Wisconsin Department of Transportation

Proposal #15: 5845-16-73
Stoughton – Madison
Harrison St to Roby Rd
USH 51
Dane County

Letting of January 13, 2026

This is Addendum No. 02, which provides for the following:

Addendum No. 02
ID 5845-16-73
Added Sheet 22A
January 9, 2026

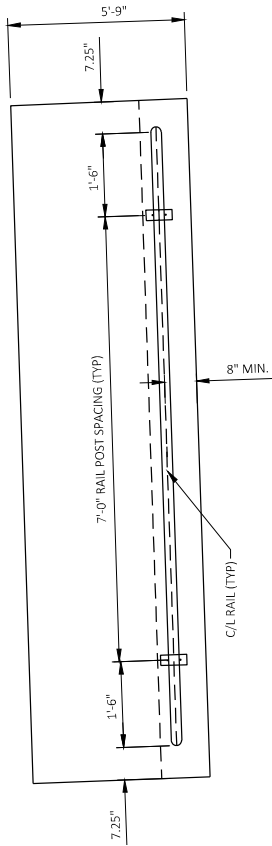
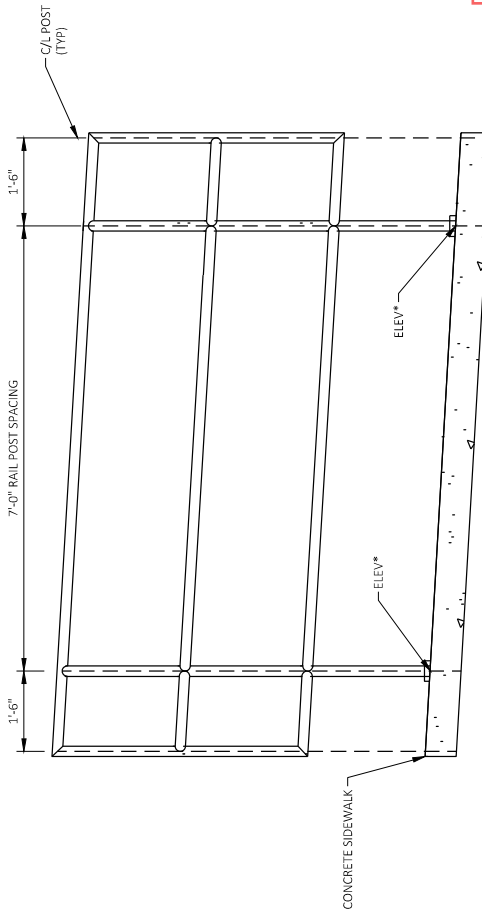
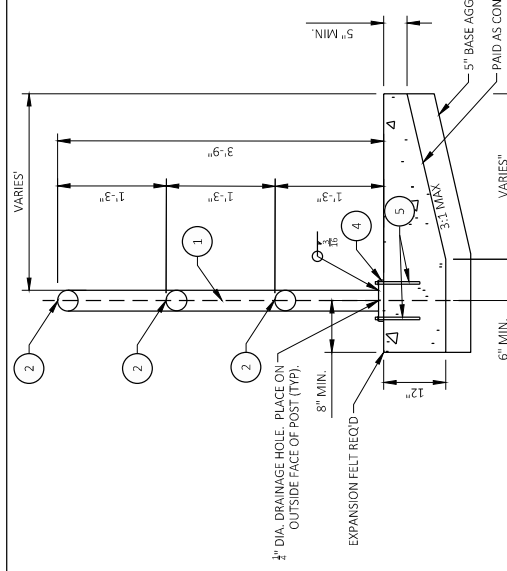
Added Plan Sheets	
Plan Sheet	Plan Sheet Title (brief description of why sheet was added)
ID 5845-16-73	
22A-22B	Construction Details (Railing Pipe detail)
577A-577AB	Computer Earthwork Data (Earthwork data tables were inadvertently not included.)

*FIELD VERIFY FINISHED ELEVATIONS PRIOR TO RAILING FABRICATION.
STA 423+33 - STA 423+43
STA 424+30 - STA 424+40

RAILING PIPE DETAIL
PAID AS "RAILING PIPE"

SHEET 46

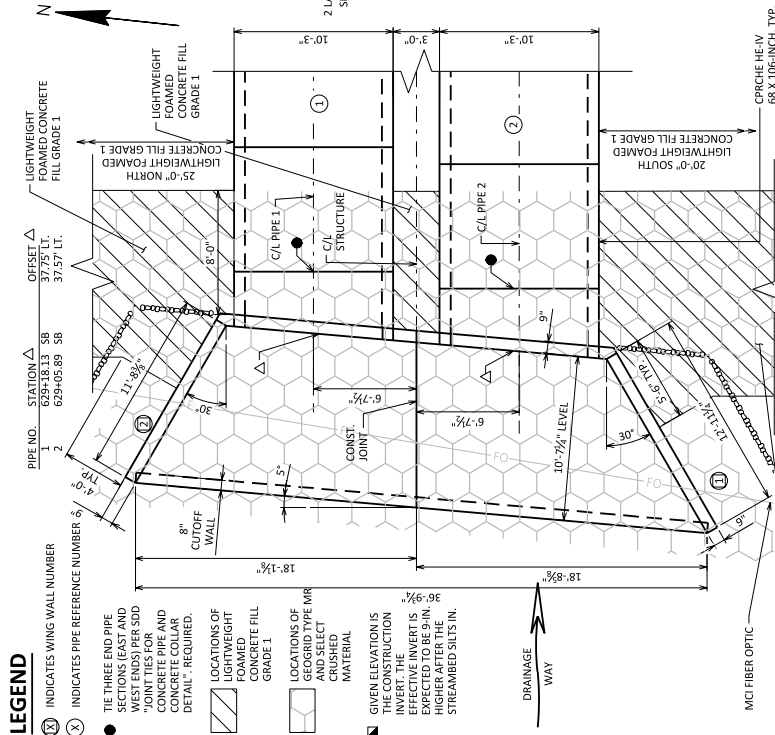
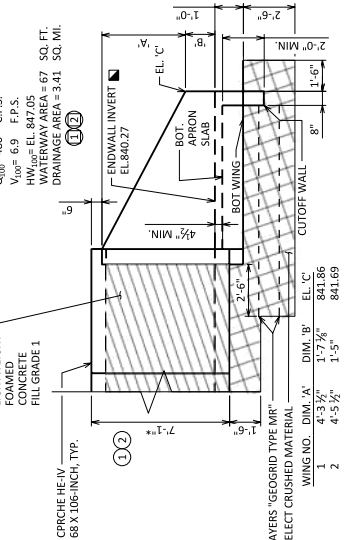
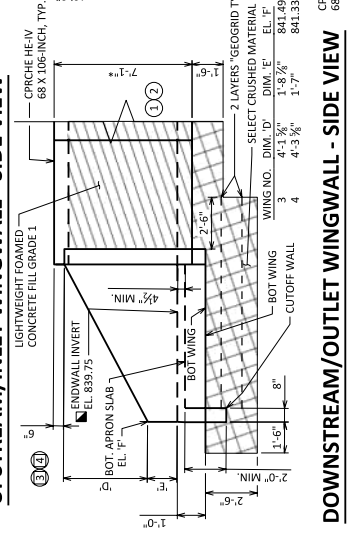
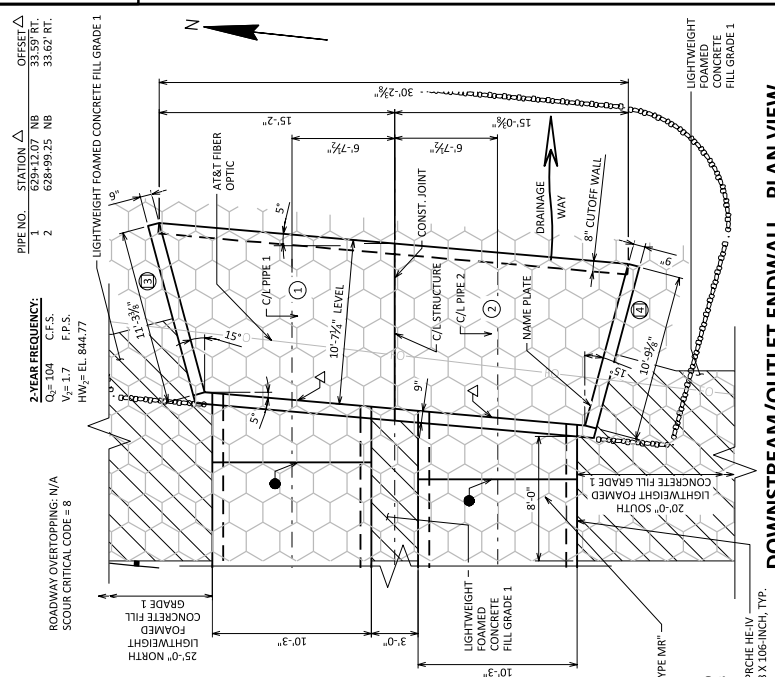
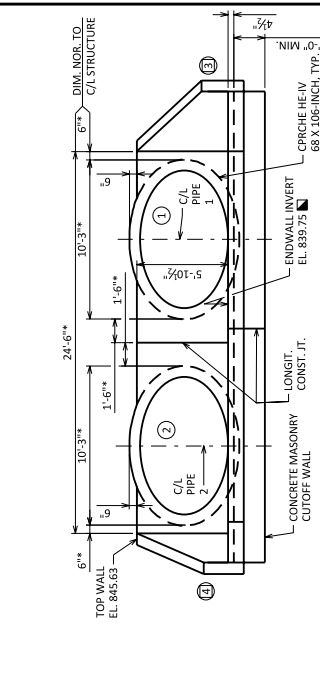
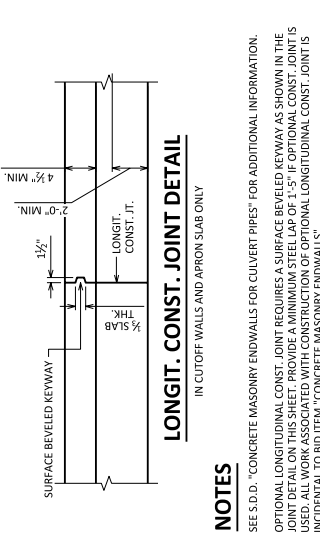
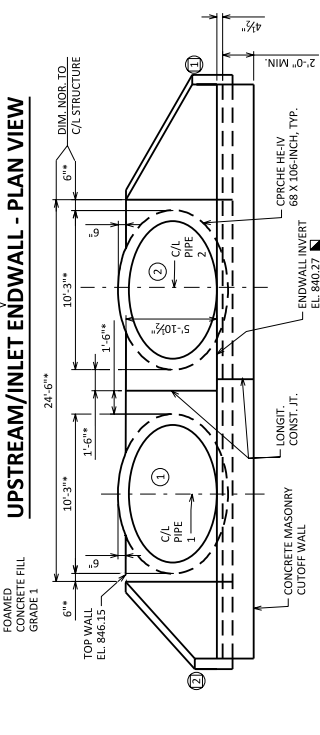
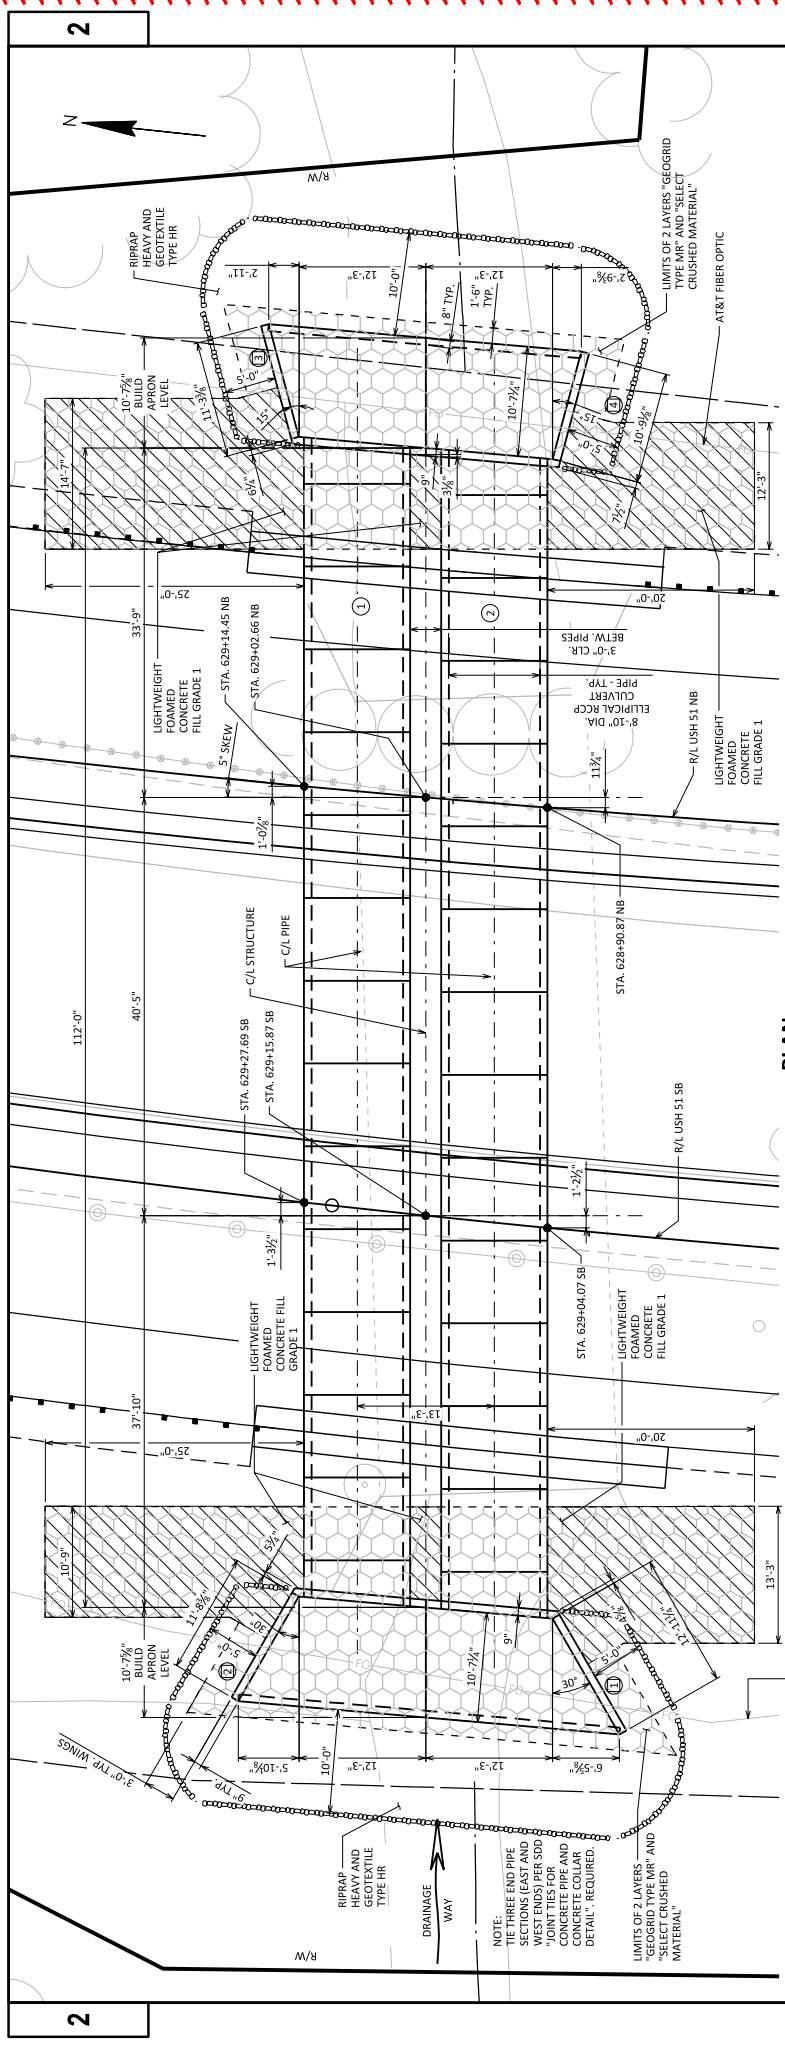
46-47	B-13-922 Construction Details (Updated B-13-922 details based on upsizing the previous 63x98-Inch pipes to 68x106-Inch pipes.)
509	Miscellaneous Quantities (Quantity revision for Presplitting Rock.)
514	Miscellaneous Quantities (Quantity revision for Select Crushed Material.)
548	Miscellaneous Quantities (Quantity revision for Geogrid Type MR.)
555	Miscellaneous Quantities (Quantity revision for Lightweight Foamed Concrete Fill Grade 1.)
557	Miscellaneous Quantities (Quantity revisions for various items due to B-13-922 updates.)
ID 5845-16-83	
9	Miscellaneous Quantities (Quantity revisions for 8-Inch D.I. Water Main and 6-Inch D.I. Water Main.)
10	Miscellaneous Quantities (Added Temporary Utility Connection, updated total quantity for 1-Inch Copper Water Service, various table updates.)
11	Miscellaneous Quantities (Table revisions.)
17	Plan and Profile (Updated water main location.)
18	Plan and Profile (Updated water main location, added Temporary Utility Connections.)

TWO CPCHC HE-NV 68 X 106 ELLIPTICAL CULVERT PIPES

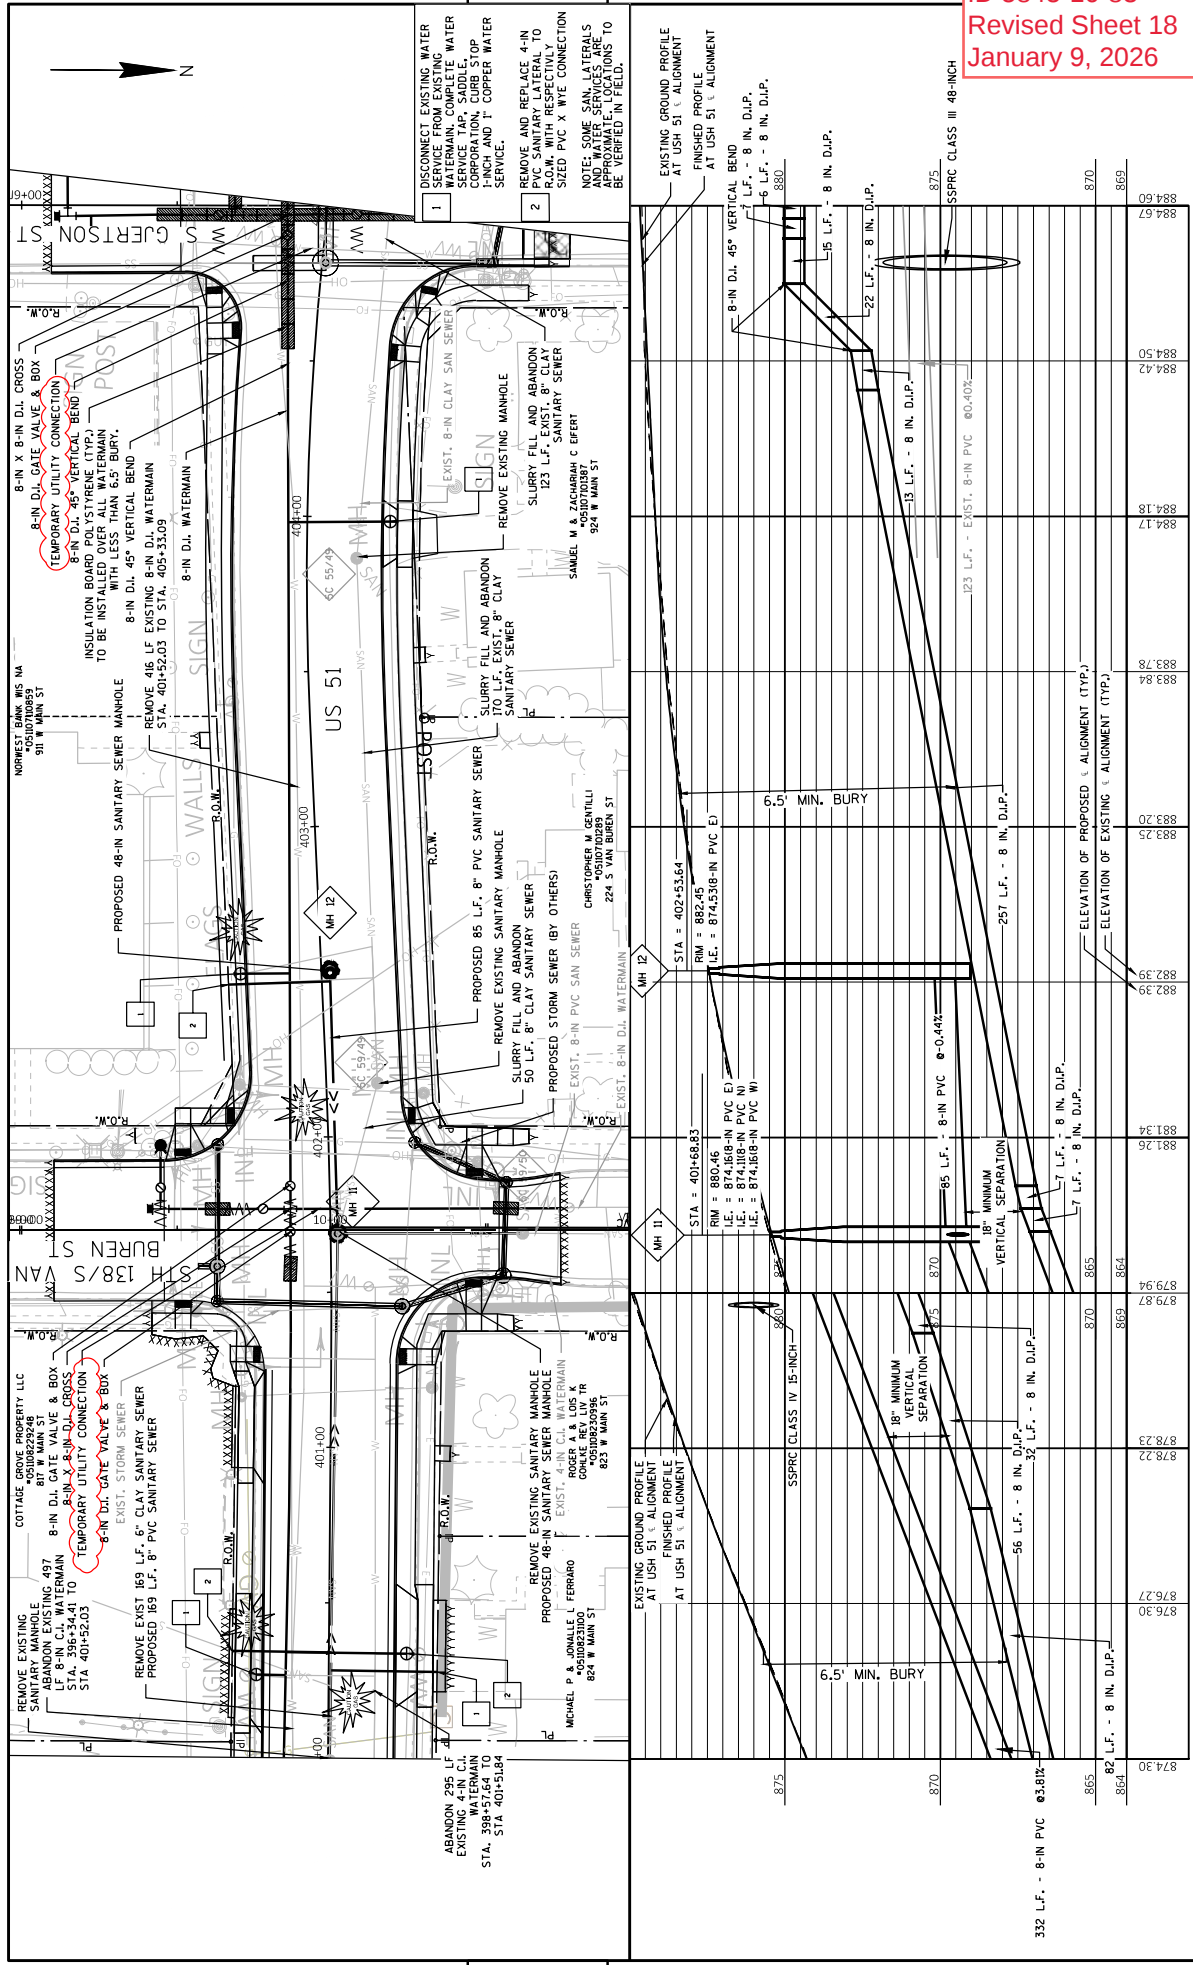
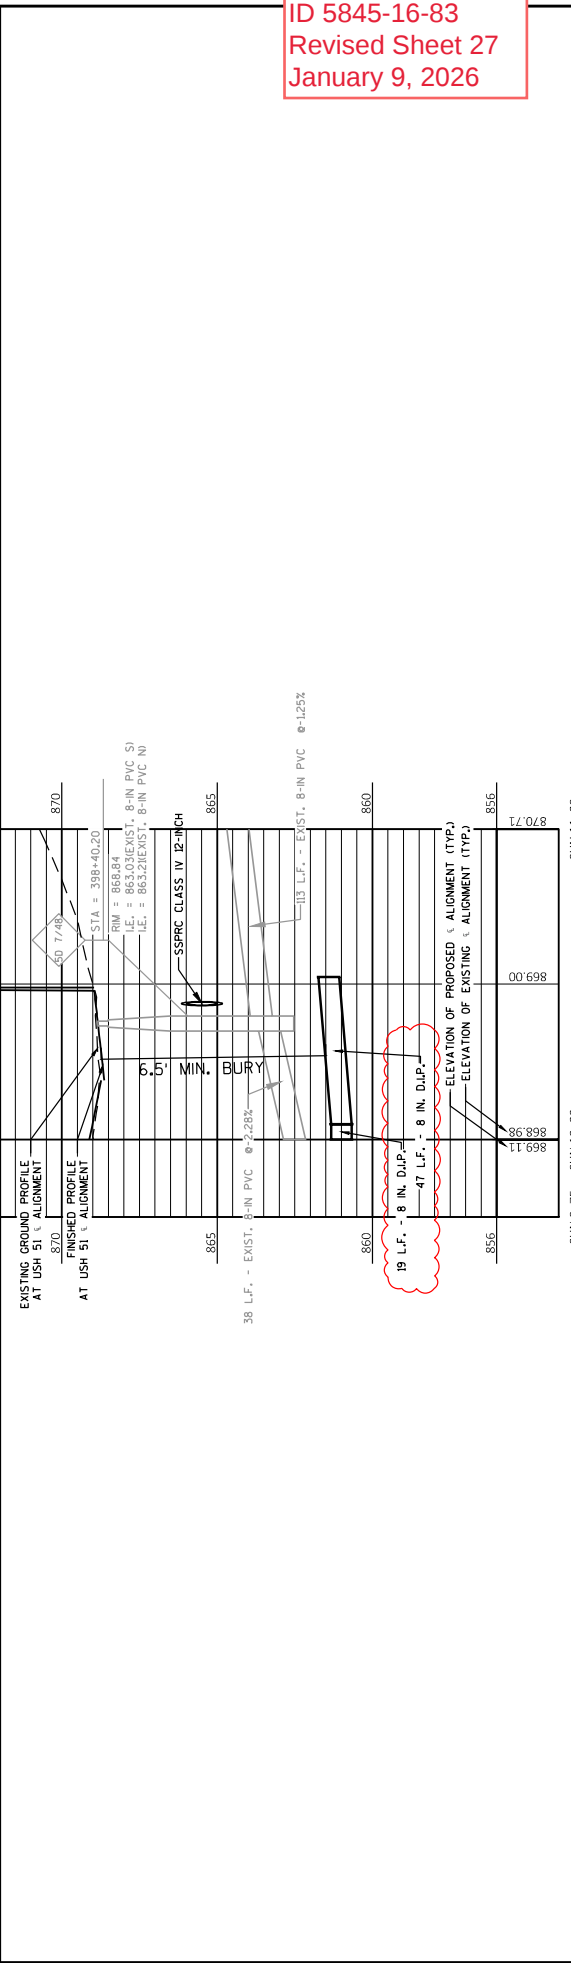
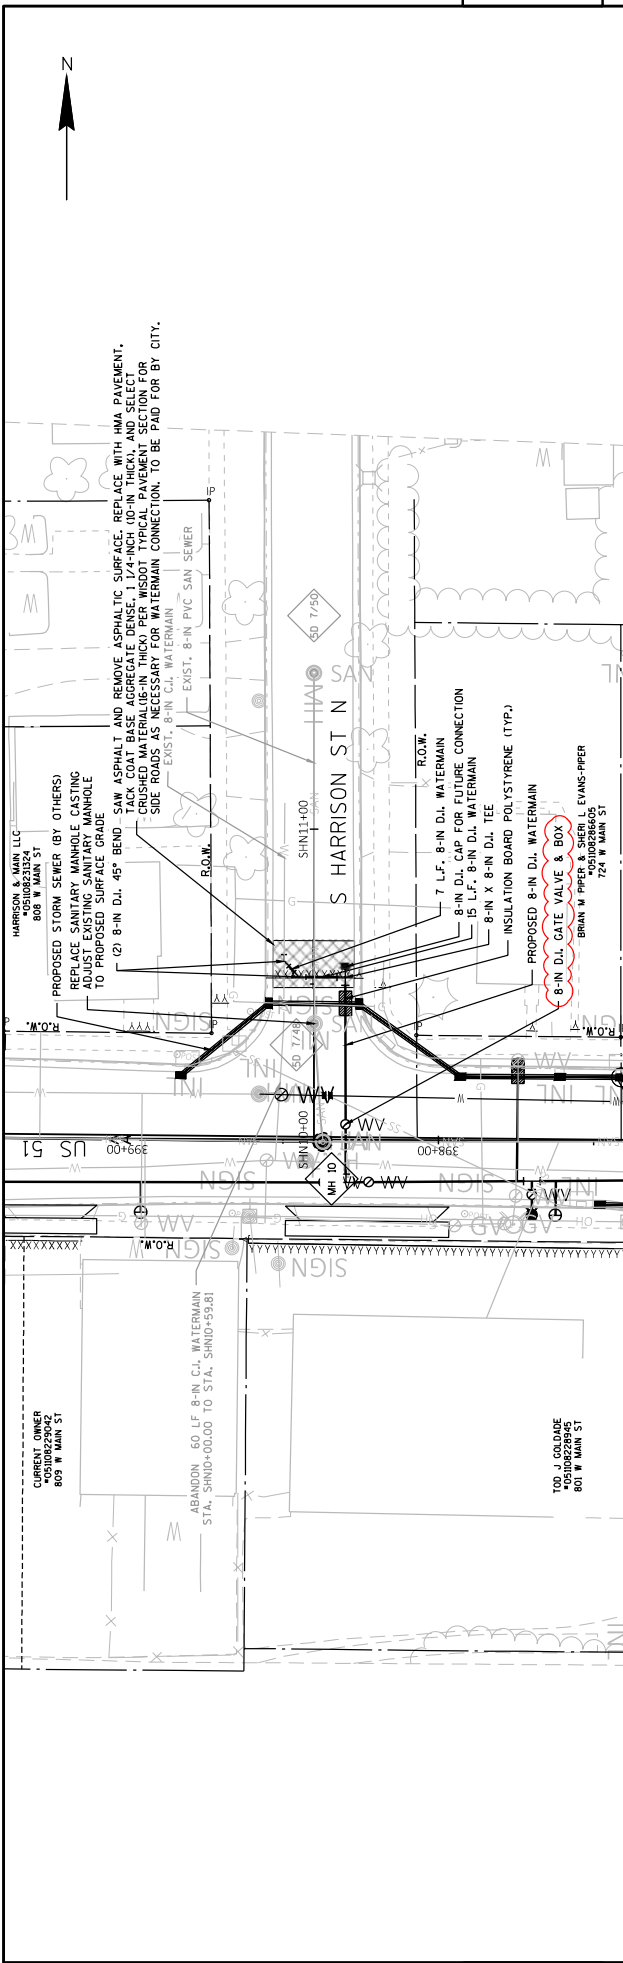
27	Plan and Profile (S. Harrison St. North water main revision.)
